# TN246

## Z180-Based Boards and Changes to the Serial EEPROM

**Figure 1. Trace Location on CM71xx Boards**

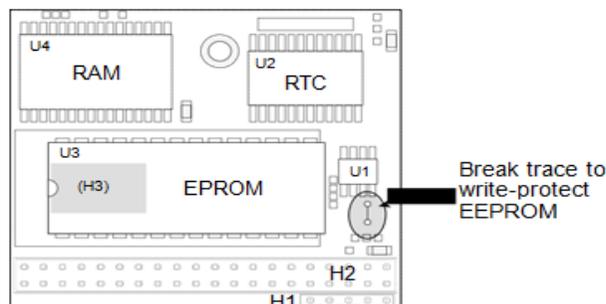
For CM71xx boards, there is a trace that controls the write-protect status. See Figure 1 for the location of the trace.
